Re: Request for Access to Records under the Freedom of Information and Protection of Privacy Act (the "Act")

All past alternative solutions and code consultant letters related to 2001 Nanton Avenue (4226 Arbutus Street is the old address for the same property).

Be: Application for Permit - 4225 Arbutus St.

Exhibit A: Architectural Drawing as originally submitted.

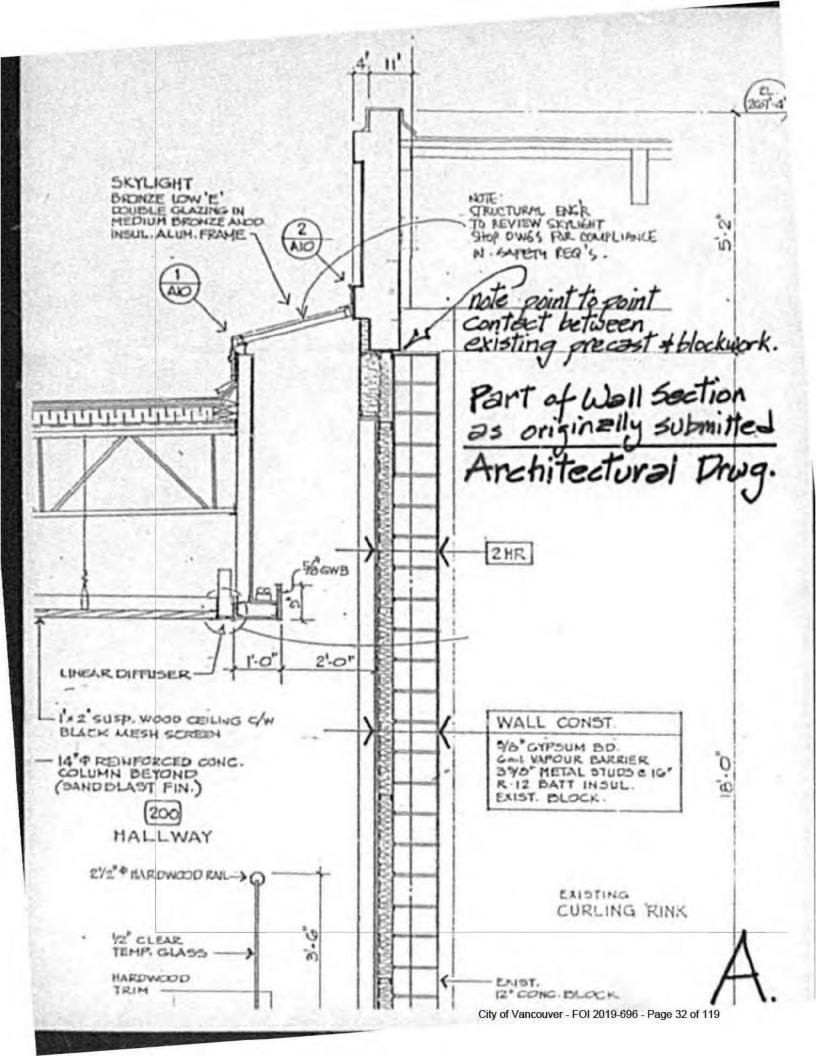
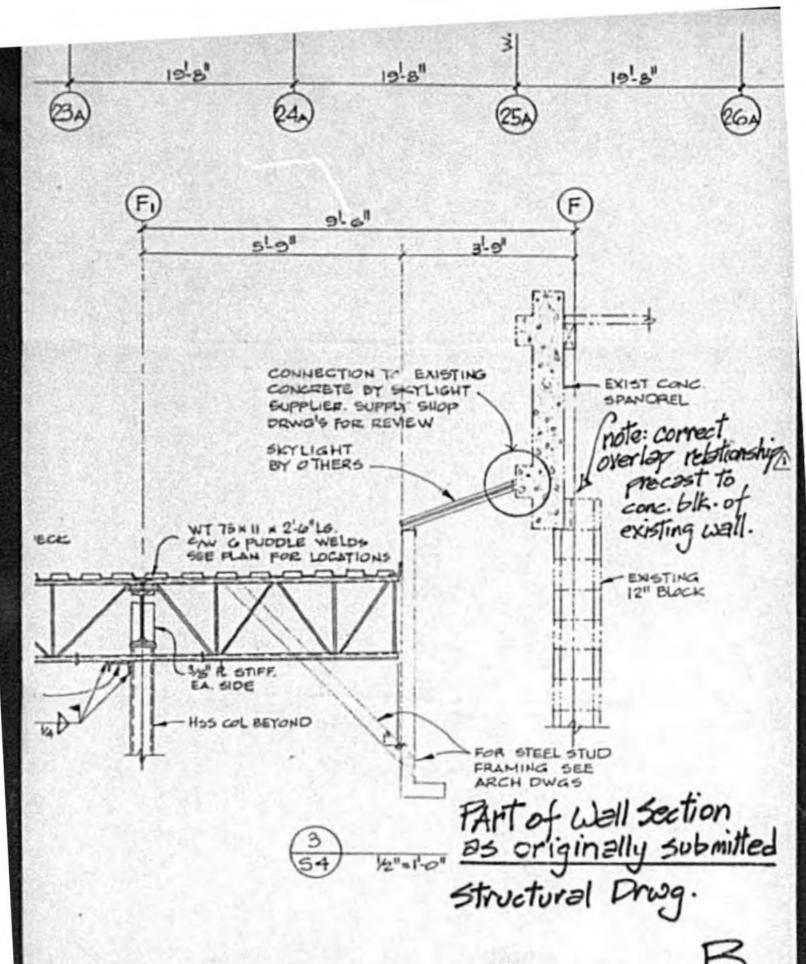
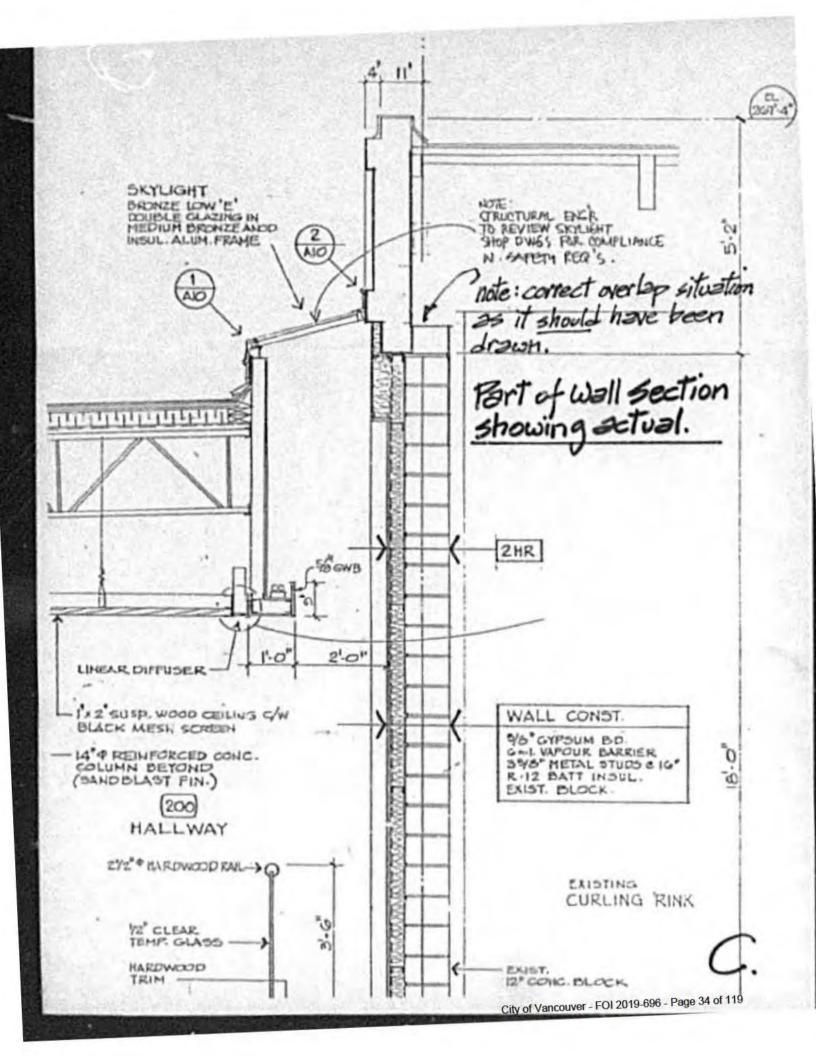
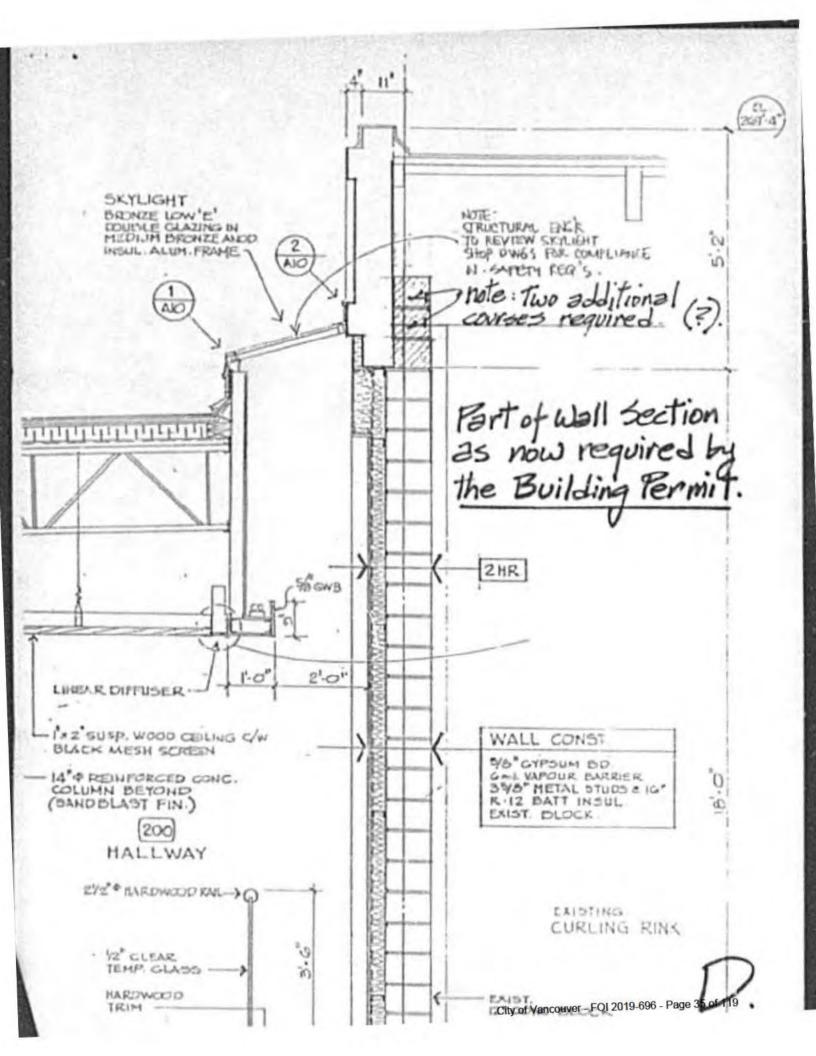
The drawing indicated in error a point-to-point relationship between the existing pre-cast parapet and the existing concrete block wall.

The structural drawing shows the actual overlap of the concrete block behind the pre-cast concrete parapet.

Had the architectural drawing been drawn correctly, it would have shown the same concrete block overlap behind the pre-cast.

The Plan Checker, having erroneous information from the Architectural Drawings (see: Exhibit A) correctly required additional courses of concrete block to maintain the Fire Separation.

Given that the existing concrete block provides adequate overlap for a normal 2-hr Fire Separation, and that the added layers of steel stud, insulation, and gypsum wallboard (non-rated) can only improve the resistance, do you feel that it is still necessary to install the two (2) courses of concrete block required by the Building Permit?

This is to provide our agreement not to require the additional two courses of concrete block subject to confirmation that the existing block wall and precast spandrel assembly are adequately constructed for structural and seismic loads, and subject to sealed architectural and structural drawings being submitted requesting a change notice to the building permit requirements.

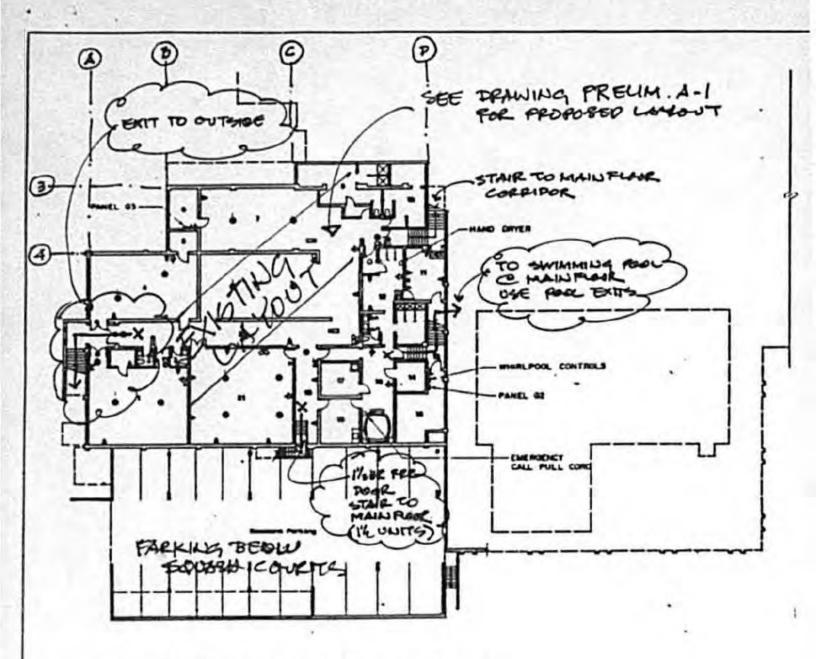
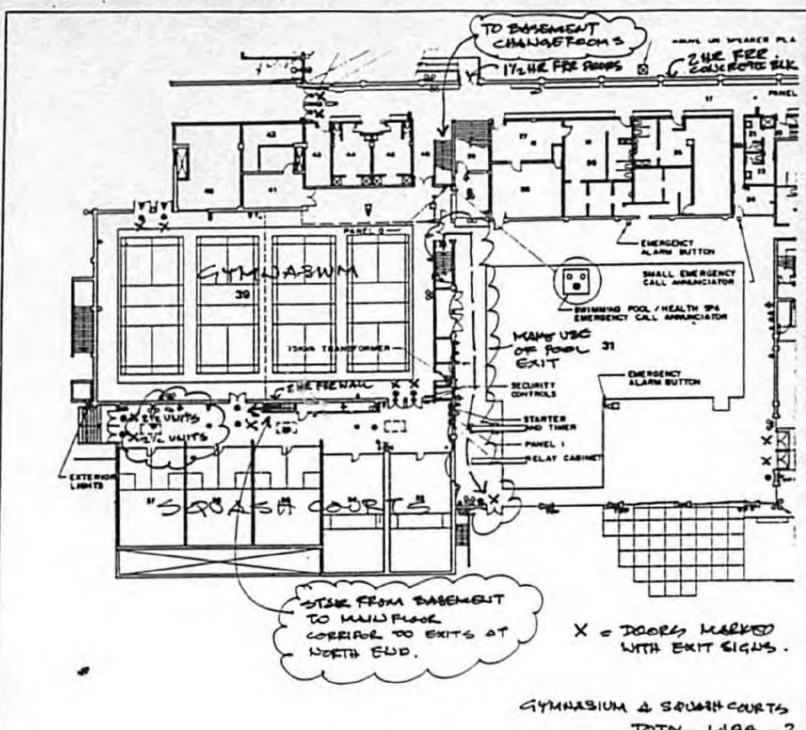
As shown on attached drawing: PRELIM A-1, a stair leads to one of two exits from this floor area (see gridlines 4 between C & D).

Presently, doors at the bottom of the stairs separate the lower floor from the access to exit (see drawing SK-1). As this is also the main entrance to the Change Rooms, it would greatly enhance the design if the doors could be deleted.

- Install Quick Response Sprinklerheads in the entire floor area.
- Use the opening in the west wall (at grid 6/C) as the second exit. This 1 1/2
  unit of exit width 1 1/2 hour FRR door in the 12\* reinforced concrete block, 2
  hour firewall, leads to a 15 feet wide corridor, adjacent to squash courts (see
  drawing SK-2)
- A third exit route can be made available, if necessary, through the south wall (grid 5/D) through the swimming pool area (see SK-1 & SK-2).
